SUBJECT: Contract Number DACW29-94-C-0079, Lake Pontchartrain, Louisiana and Vicinity, High Level Plan, London Avenue Outfall Canal, Parallel Protection, Mirabeau Avenue to Leon C. Simon Boulevard Floodwall, Orleans Parish, Louisiana, B & K Construction Company, Incorporated, **Labor Charge Nos. BEC2131C1L10LML and BEC2131B0L10LML**

SUBJECT: Contract No. DACW29-94-C-0079, Lake Pontchartrain and Vicinity, High Level Plan, London Avenue Outfall Canal, Parallel Protection, Mirabeau Avenue to Leon C. Simon Blvd. Floodwall, Orleans Parish, Louisiana

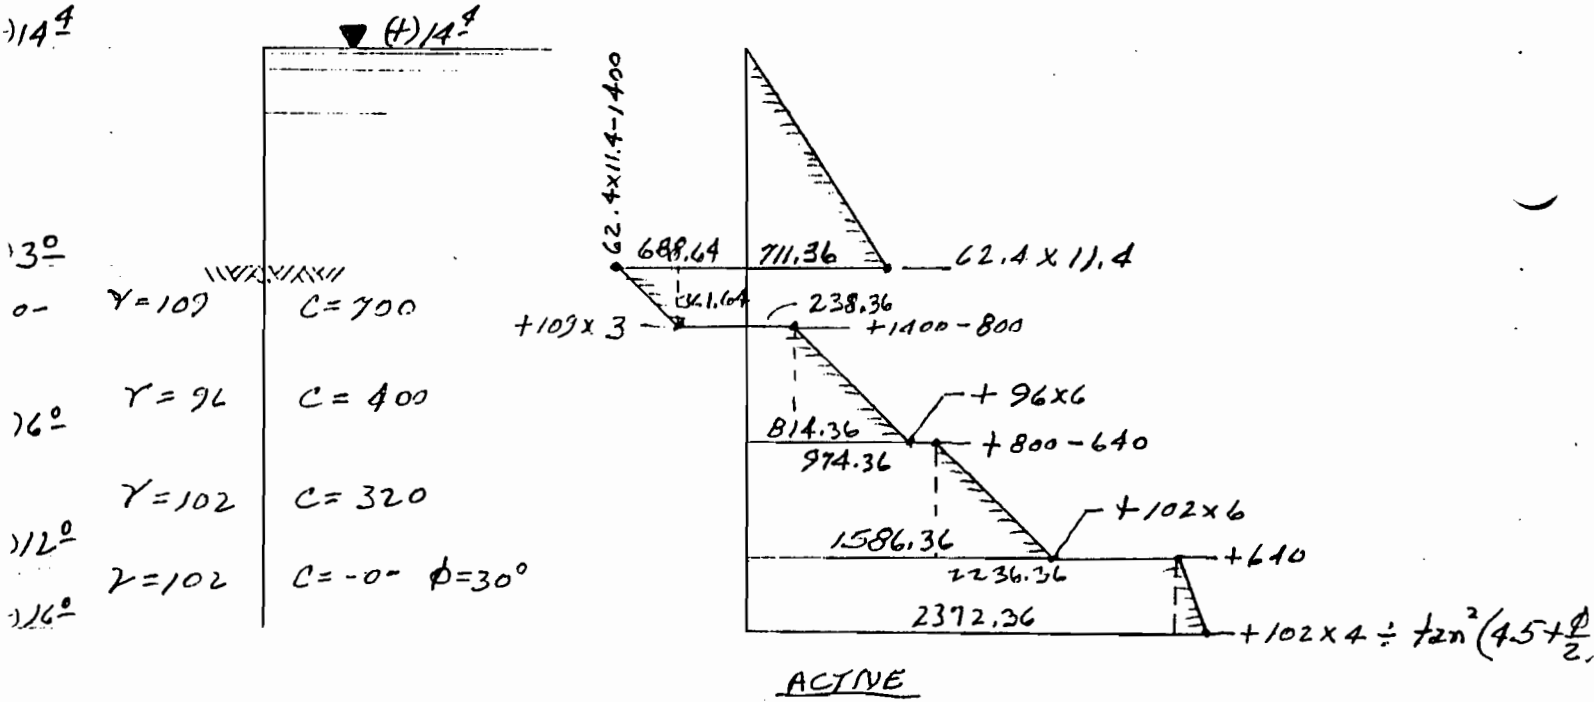
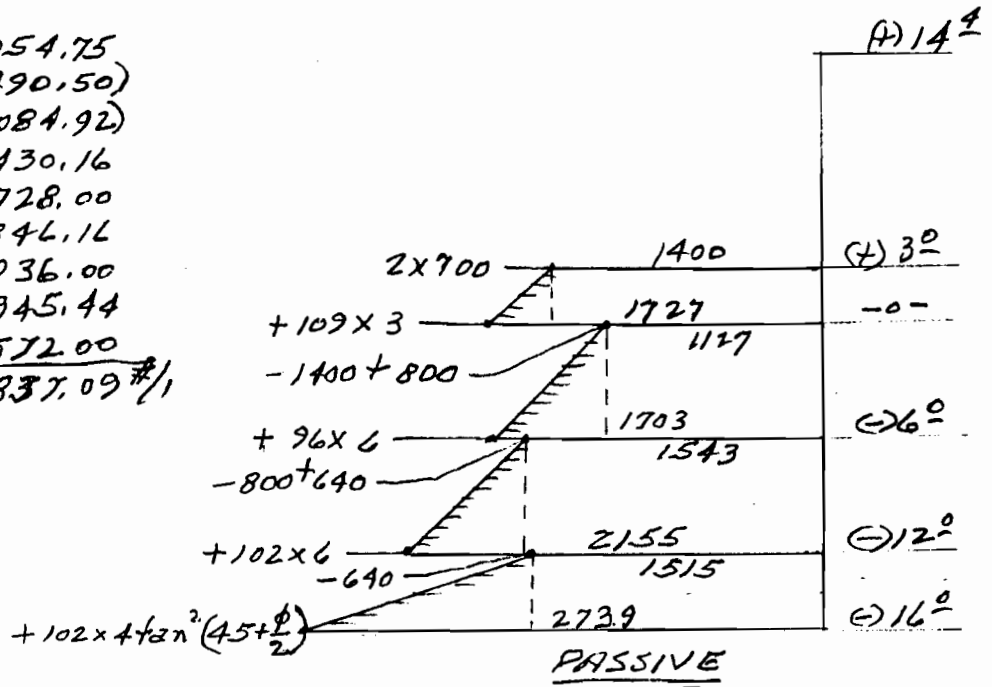
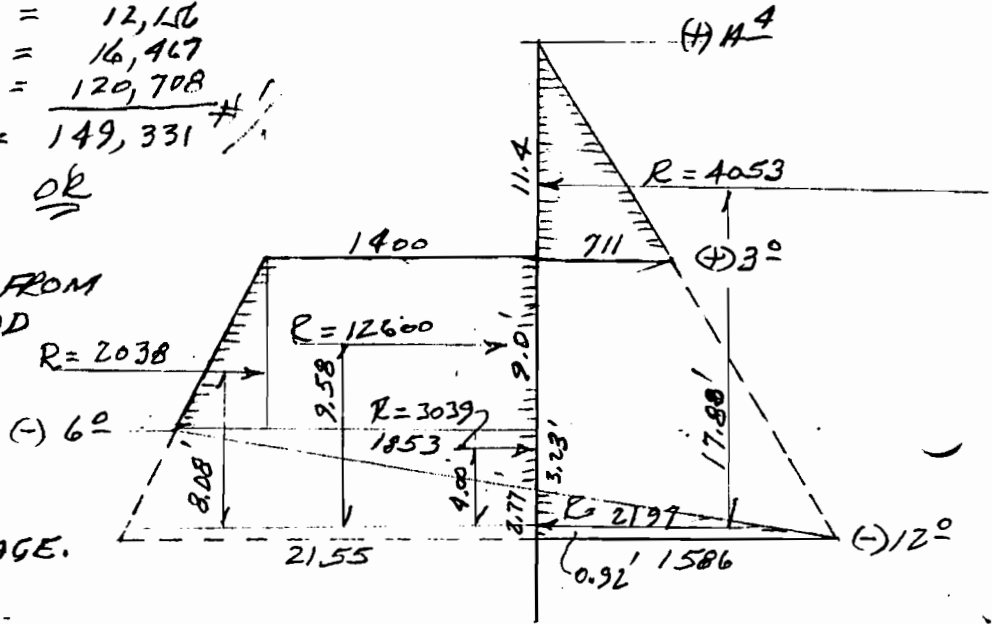
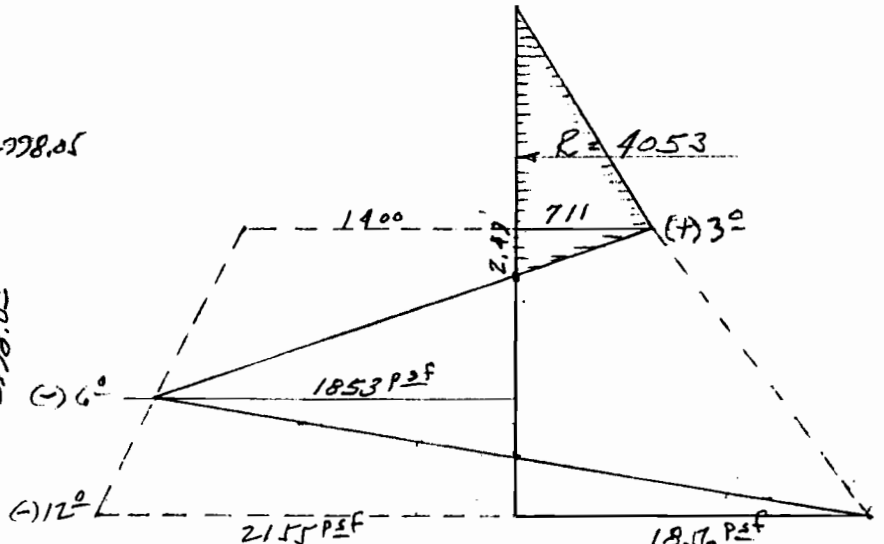
1. Design Criteria Slope Stability. Slope stability performed by LMVD Method of Planes Analysis (Wedge Analysis) for a minimum factor of safety of 1.3 with respect to the design shear strength. Floodside analysis low water elevation -5.0. Protected side analysis high water elevation 11.9. Piezometric headline at elevation -3.0. The wedge stability computer program used by Corps is Stability with Uplift (FS004).

Using the resulting shear strengths, net lateral water and earth pressure diagrams are determined for movement toward each side of the sheet pile. Using these distributions of pressure, the summation of horizontal forces is equated to zero for various tip penetrations. At these penetrations summations of overturning moments about the sheet pile are determined. The required depths of penetration to satisfy the stability criteria are determined as those where summation of moments is equal to zero. The sheet pile wall design criteria is:

Reference your temporary flood protection plan submitted May 16, 1995 for the area between west baseline station 119+62.82 to 102+81 on the subject contract.

Your plan is acceptable for use provided your company complies with the provisions of this plan and the related specifications in the contract. You will also be required to backfill the structural excavation to a minimum El. 3.0 N.G.V.D. in the event of a hurricane.

BY _____ DATE 5-22-95 SUBJECT LONDON AV. CANAL HURRICANE PROTECTION SHEET NO. 1 OF 1

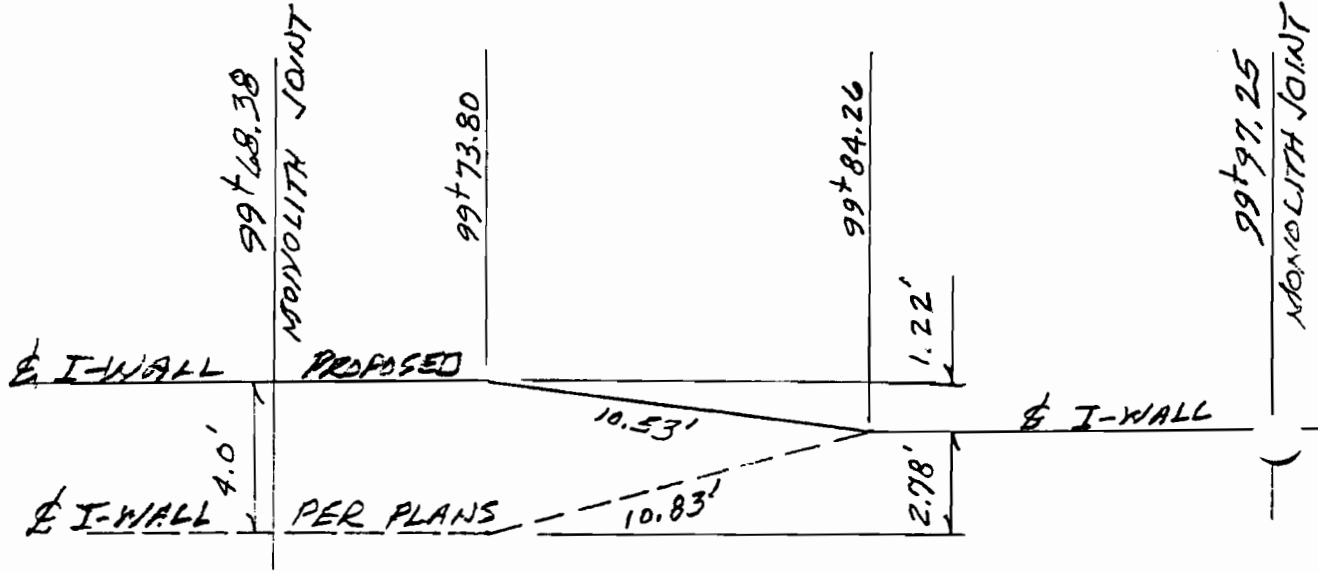
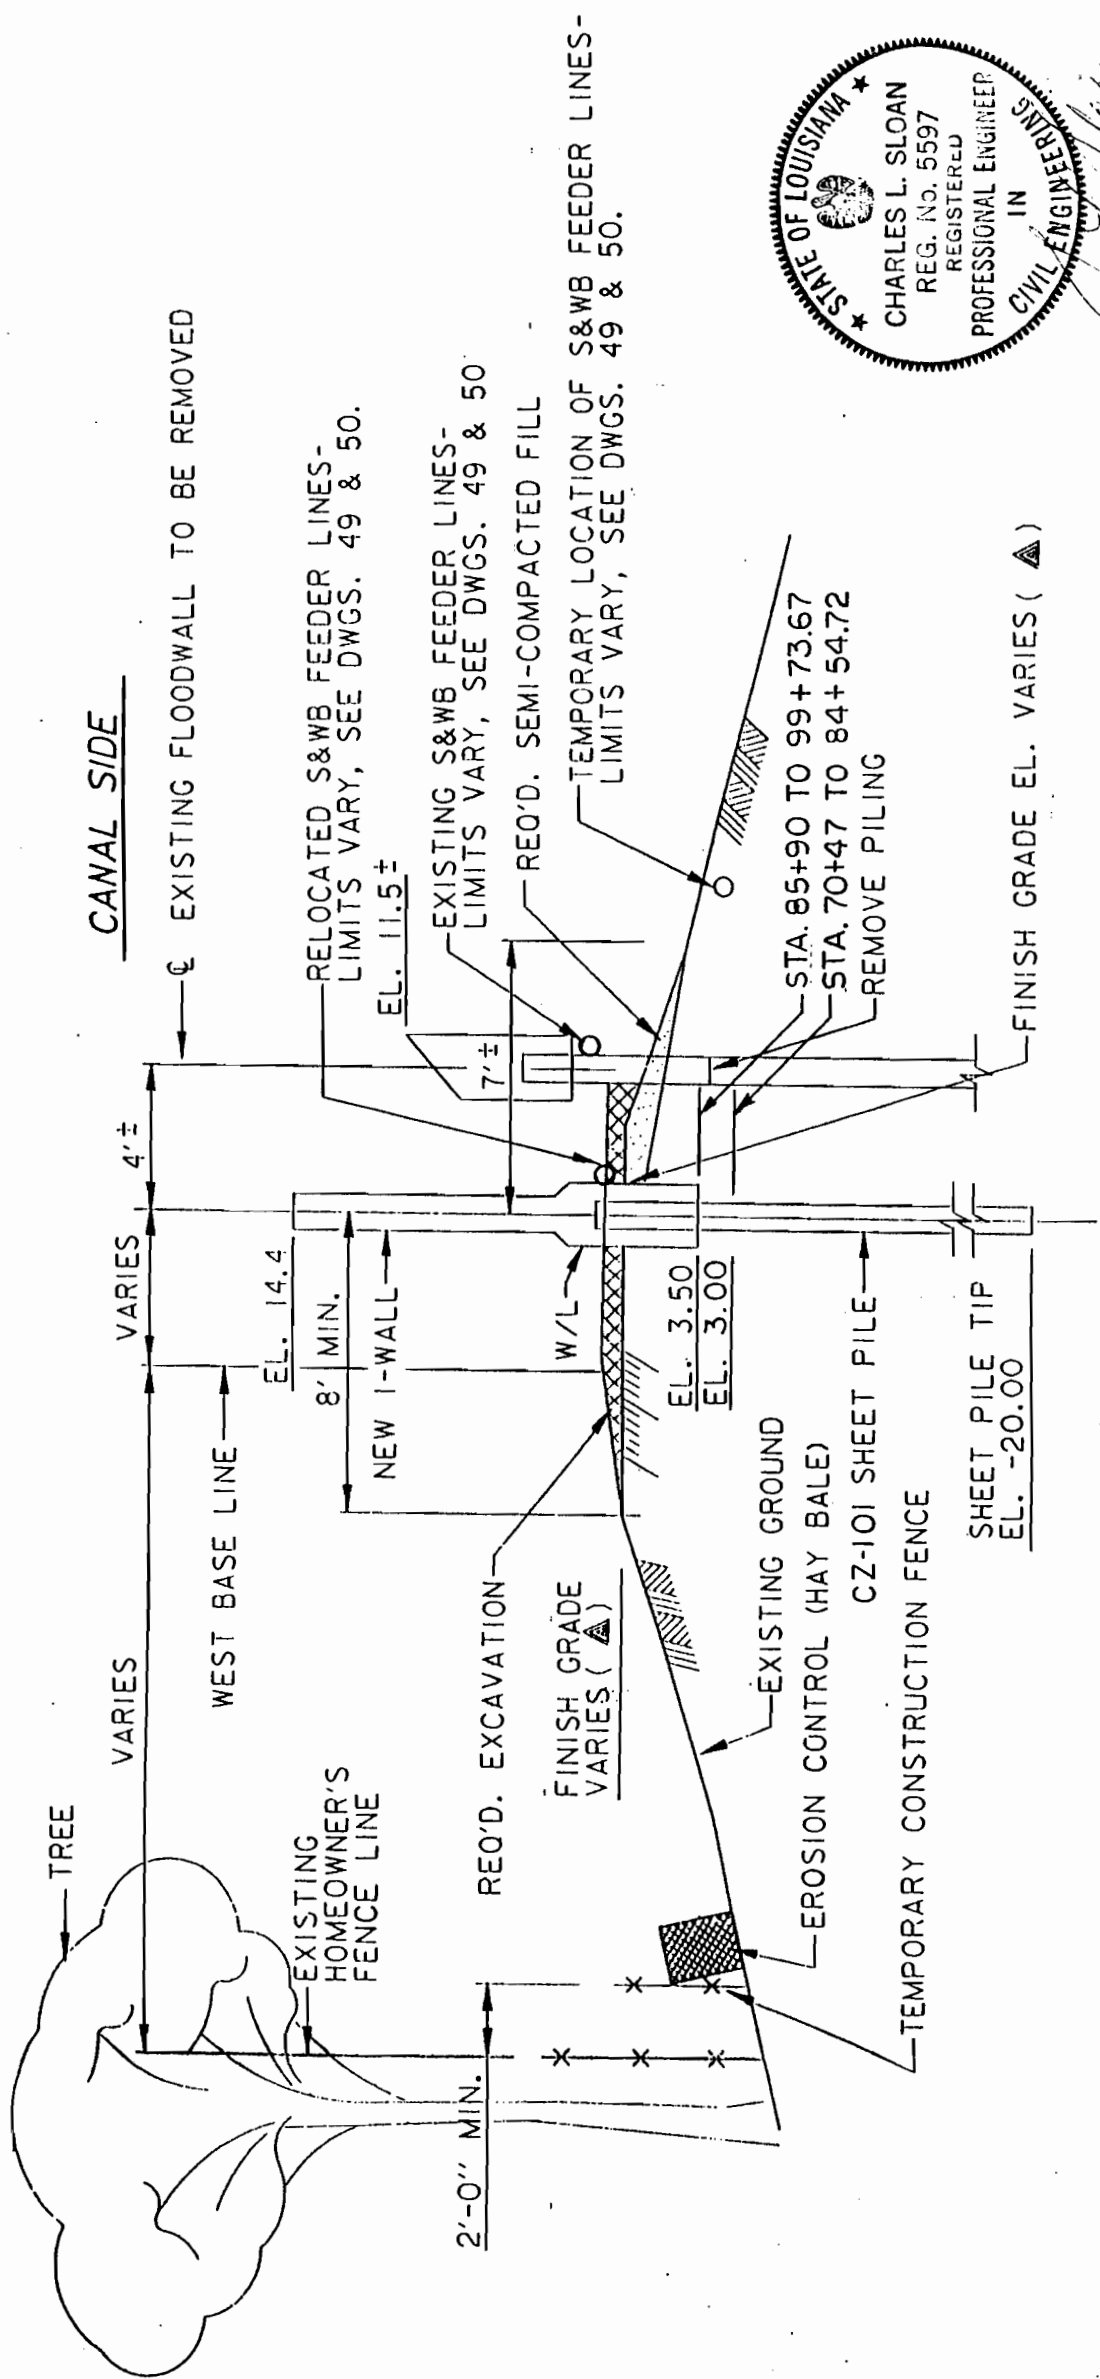
THIS PROPOSED CHANGE IN ALIGNMENT WILL NOT AFFECT THE NUMBER OF PILE SECTIONS OR THE MONOLITH JOINT STATIONS.

EXIST. MP-115 SHEET PILING
TO BE CUT 6" BELOW FINISHED GRADE
REMOVE EXISTING CONC. CAP (*)
PIECE OF EXISTING MP-115
SHEET PILING TO BE REMOVED

NOTE "A":
COLLAR TO INCLUDE AT LEAST ONE CZ 101 SO
THAT WHEN COLLAR IS REMOVED FOR FUTURE
I-WALL THERE IS A SHEET PILE TO INTERLOCK

(*) EXPOSE AND CLEAN EXISTING LONGITUDINAL REBARS
AND EXTEND THESE REBARS 1'-6"
INTO THE NEW CONCRETE COLLAR.
(▲) ALL TIES ARE TO BE FIELD BENT.
(●) #6 L-BARS TO LAP #6 BARS
AS SHOWN IN PLAN AT
